REQUEST FOR BID ON
OPW 52182
74th and Nina Lift Station Abandonment

ADDENDUM NO. 1:

PROJECT NO: OPW 52182 – 74th and Nina Lift Station Abandonment

SITE PLAN

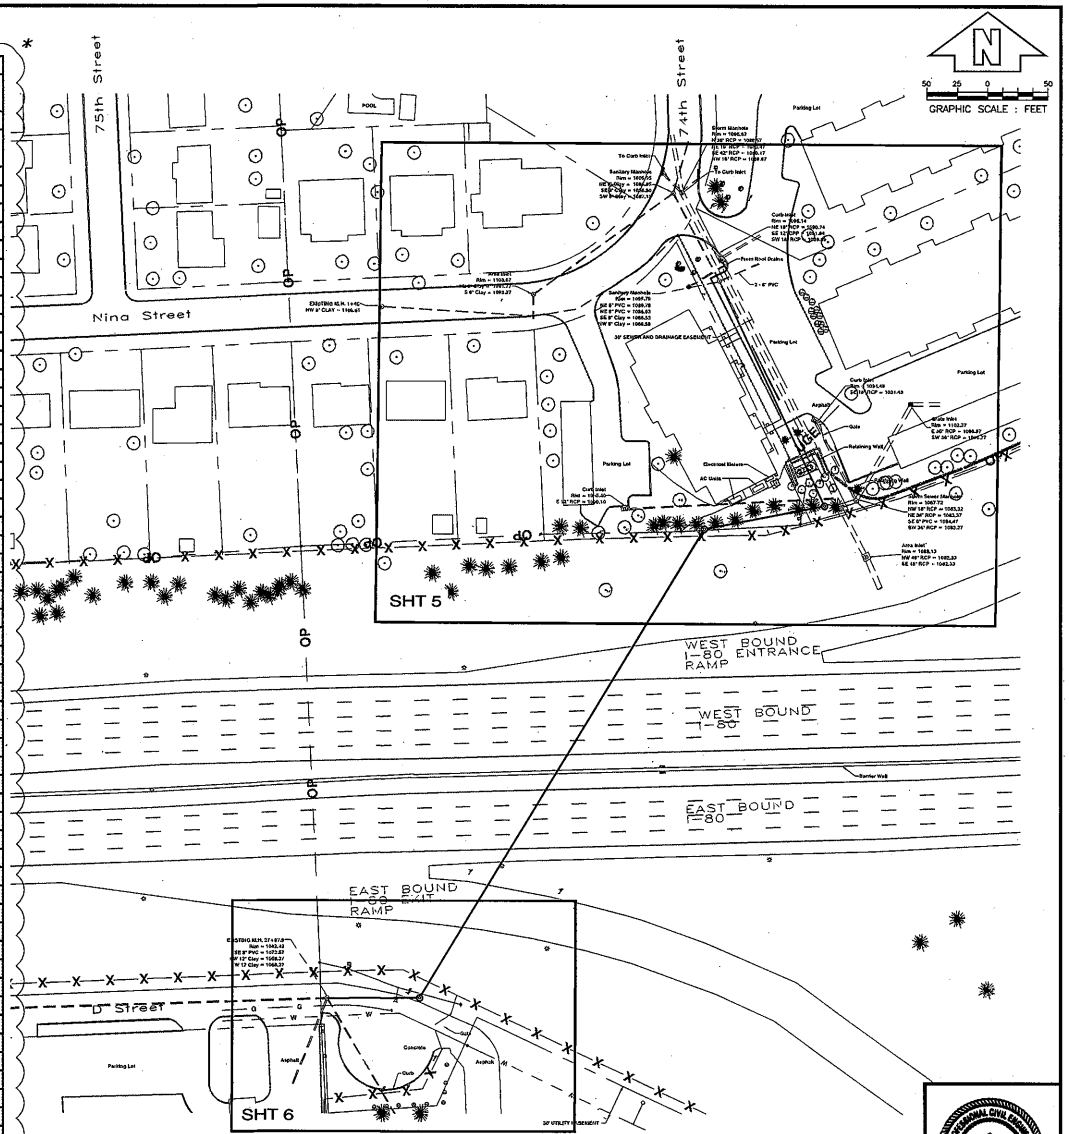
A. Plan Sheet 2, Approximate Bid Quantities, Line item number 12, replace Unit "EA" with "LS."

B. Plan Sheet 2, Approximate Bid Quantities, Line item number 27, replace Bid Item "201.300" with "202.100."

C. Plan Sheet 2, Approximate Bid Quantities, Line item number 29, replace Bid Item "401.405" with "401.500."

D. Plan Sheet 2, Approximate Bid Quantities, Line item number 33, replace Unit "TON" with "LF."

E. Plan Sheet 2, Approximate Bid Quantities, Line item number 49, replace Approximate Quantity "30" with "1."

F. Plan Sheet 2, Approximate Bid Quantities, add the following:

56	**905.031**	**Install Permanent Paint Marking – 4" YELLOW**	**162**	**LF**

REMOVAL PLAN NORTH

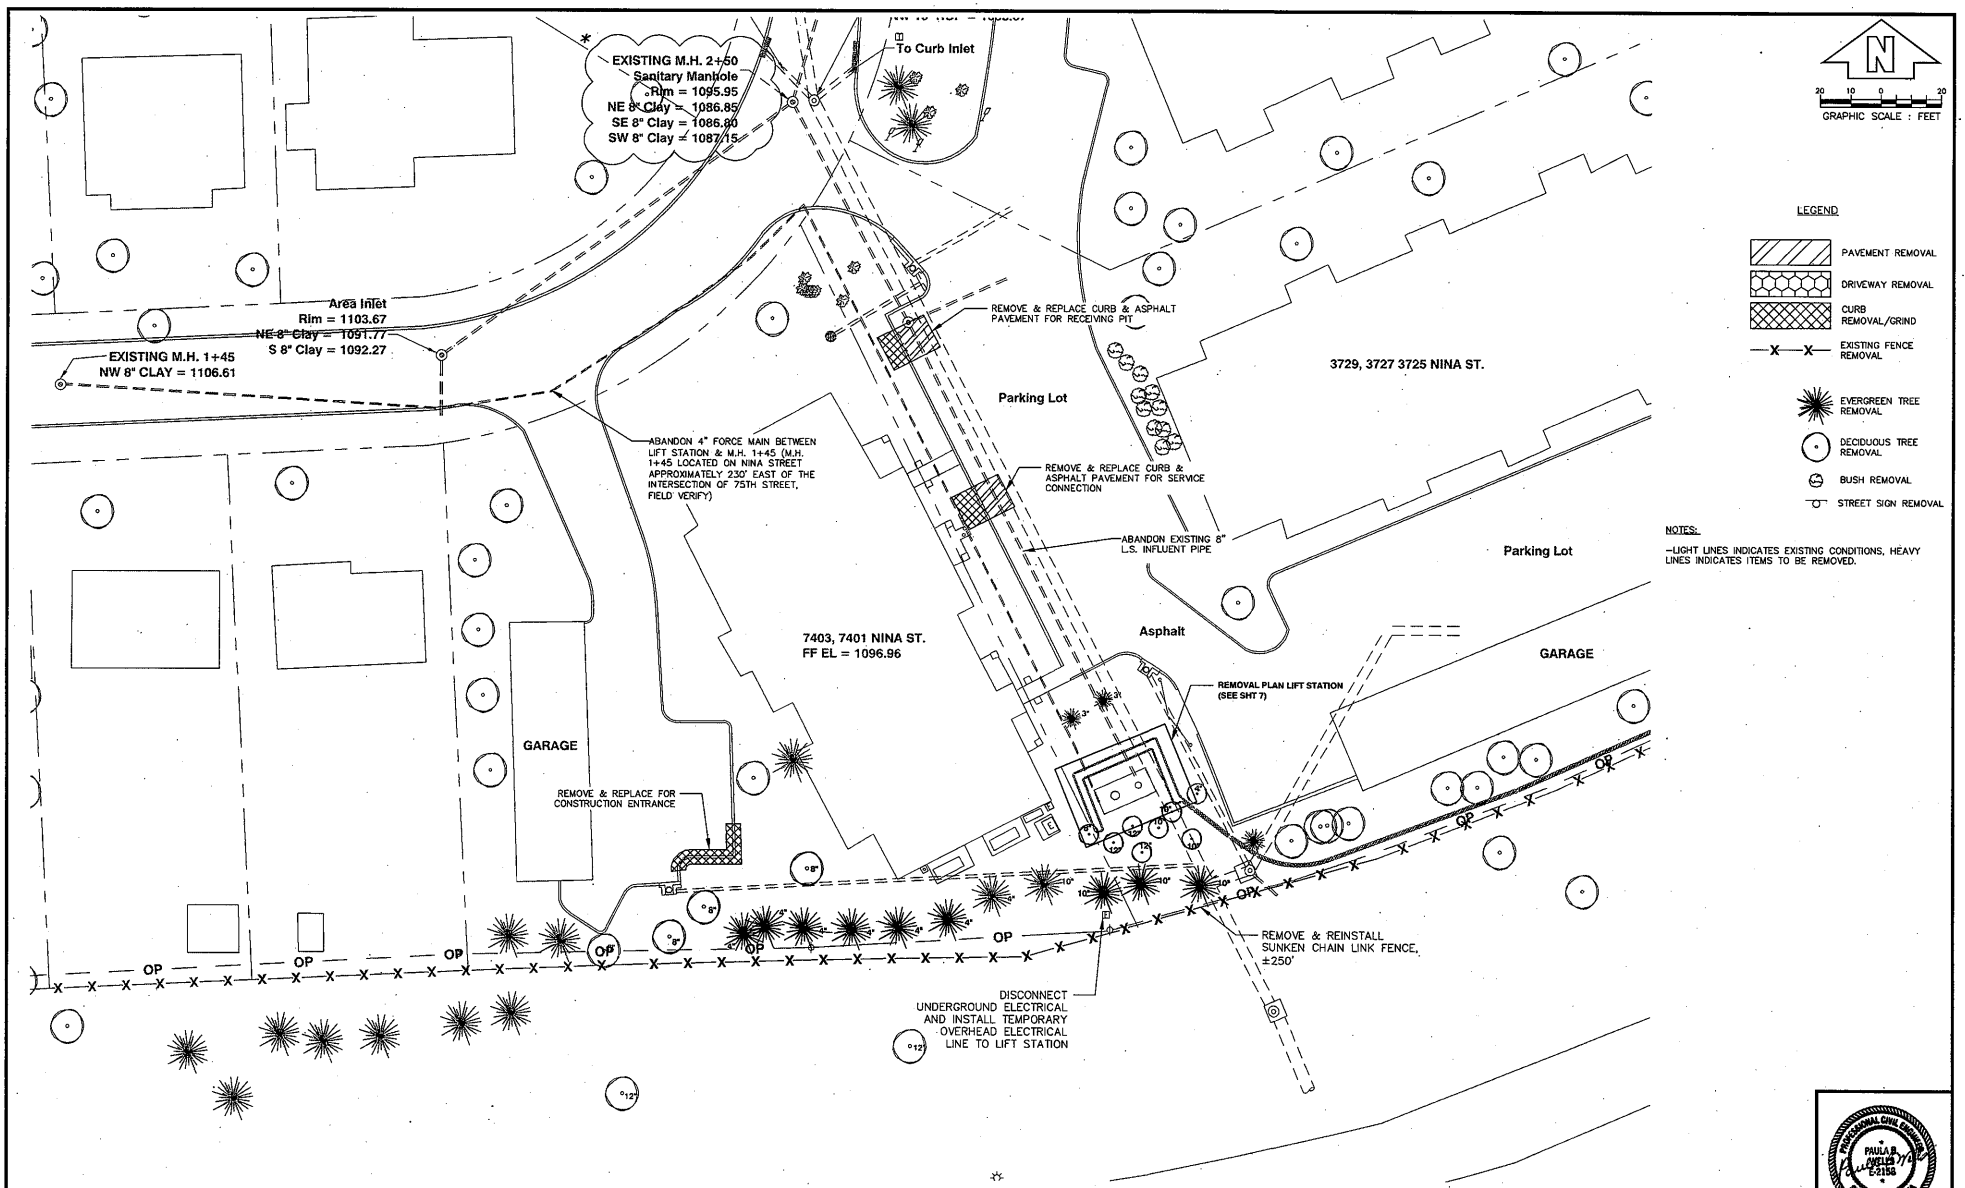
G. Plan Sheet 5, Top of page, add note "Existing M.H. 2+50."

2. **Q: S.P.-1, number 8 says to "Commence bypass pumping of sanitary sewer flow from existing MH No. 2+50 to existing MH No 1+48". Could you point out which manholes these are? The only one close in reference to either of these is the manhole at STA. 1+45 as shown on sheet 5 of the drawings.**

A. *The note referring to manhole "No 1+48" should read as "No 1+45." The attached reissued plan sheet 5 indicates the locations of each manhole.*

REMOVAL PLAN SOUTH

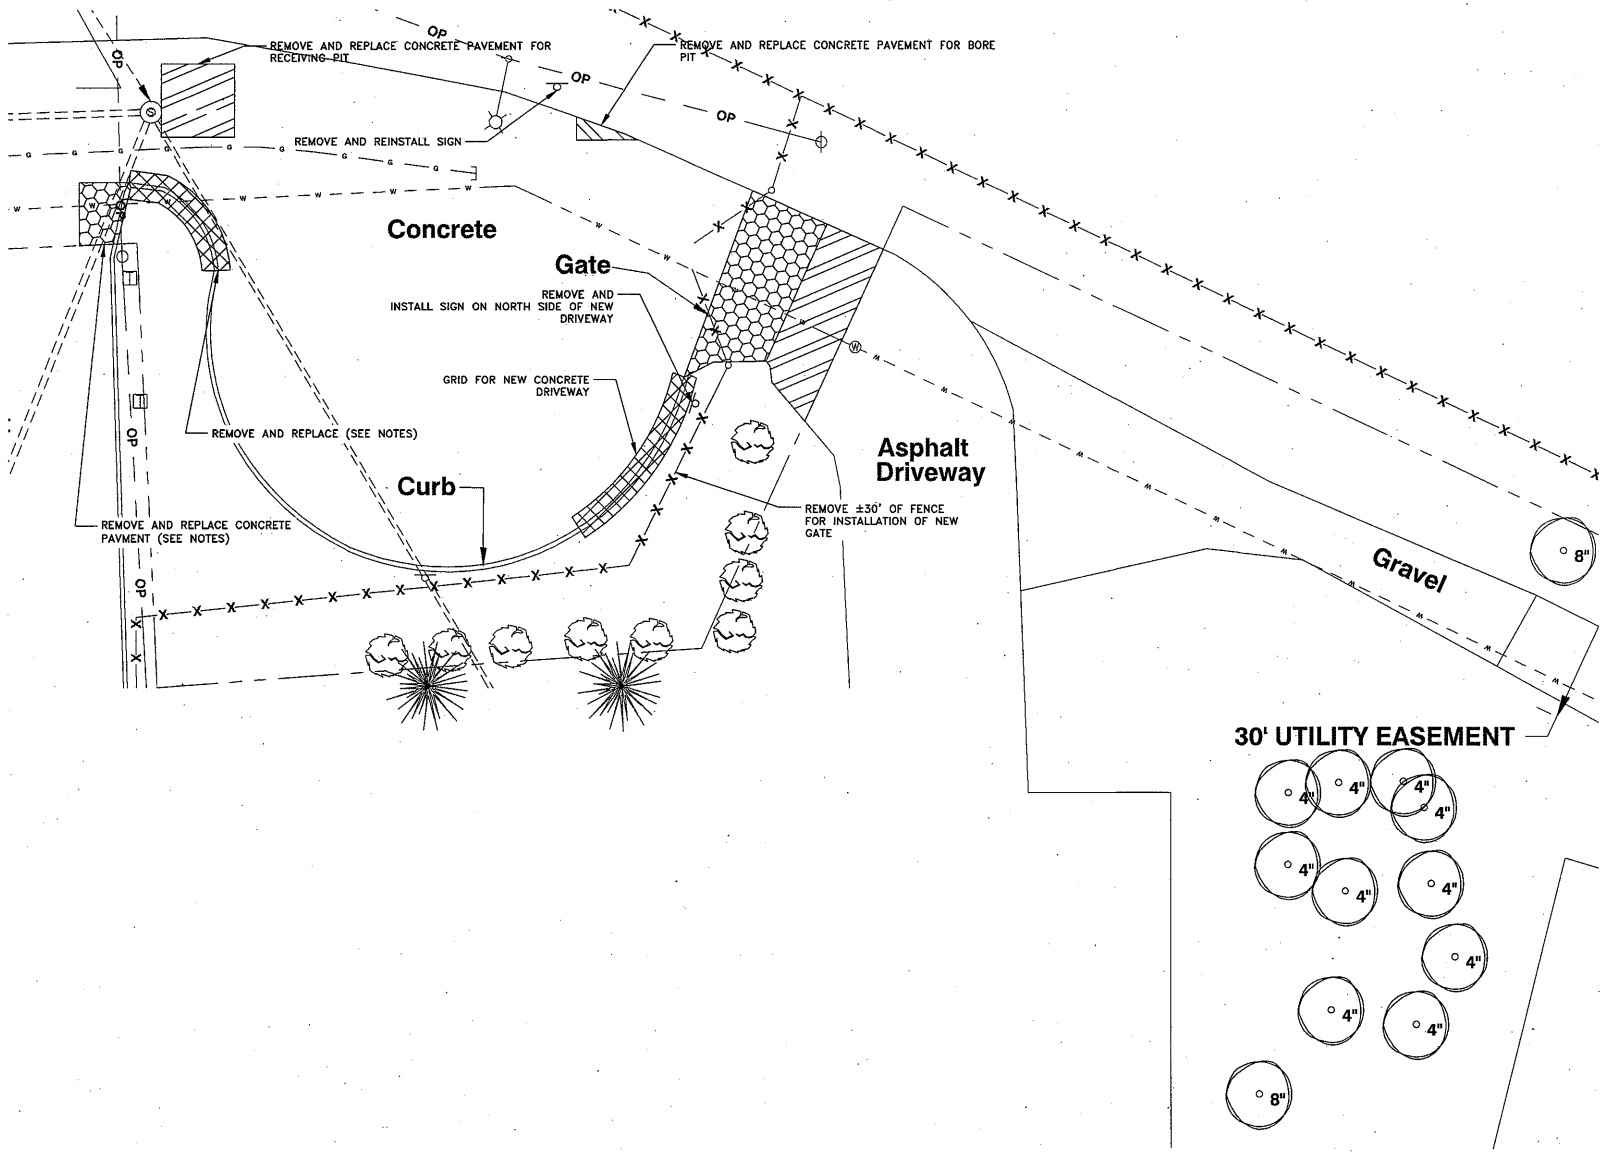
H. Plan Sheet 6, Top right of page, change scale from 1"=50' to 1"=10'.

EASEMENT LAYOUT PLAN SOUTH

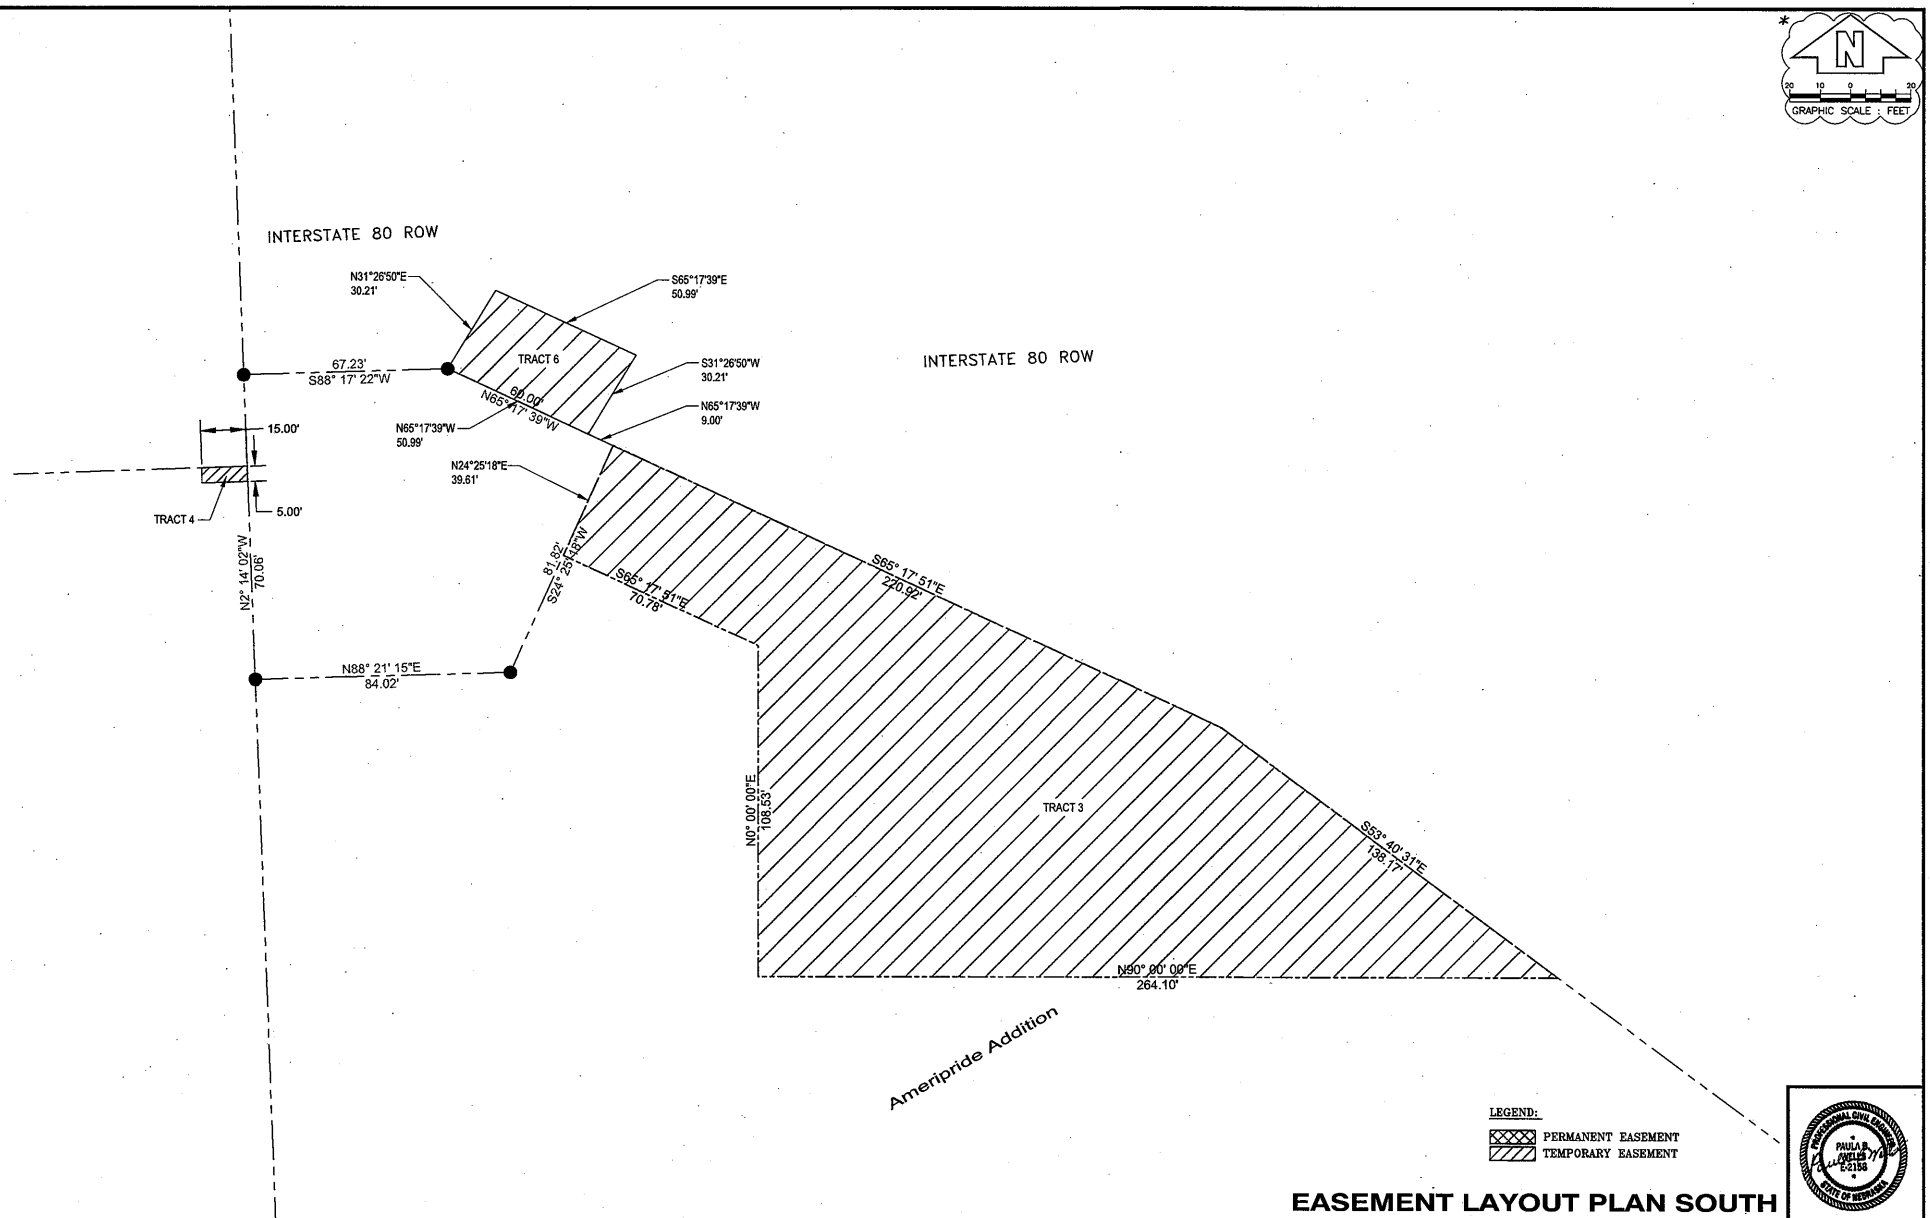
I. Plan Sheet 9, Top right of page, change scale from 1"=50' to 1"=20'.
